No. 91-10

A. STARTER RELAY "CHATTER" ON DIESEL ENGINES

MCM/MIE 530/D183
MCM/MIE 636/D219
MCM/MIE D254

50908

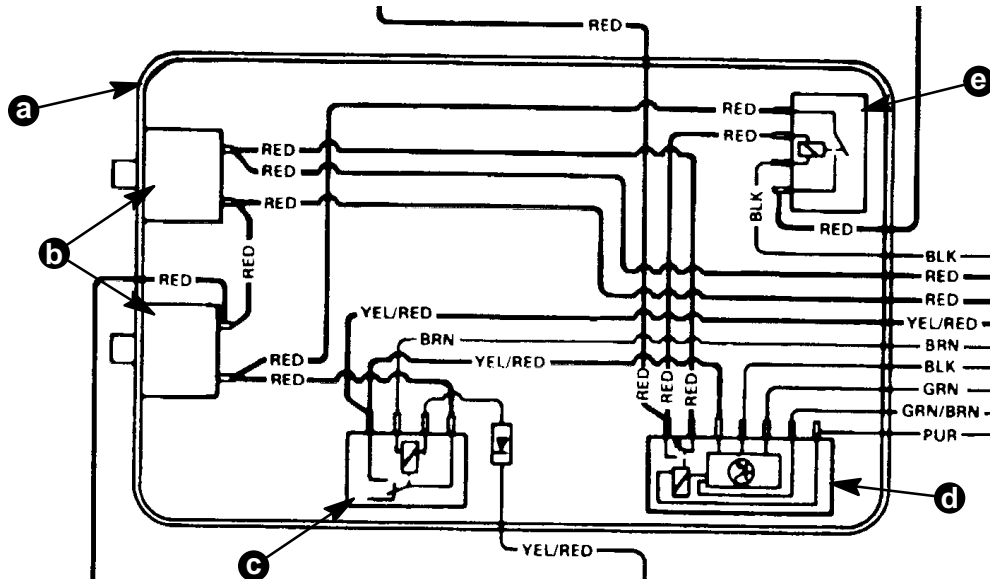
Sometimes the starter relay will "chatter" when trying to start the engine. This starter relay is inside the electrical box mounted on the port side of the engine.

A new starter relay has been released to correct this problem. Remove electrical box cover. Inspect the starter relay. If it has 12V on it, install new 6V relay.

(1) 87-821173 Starter Relay
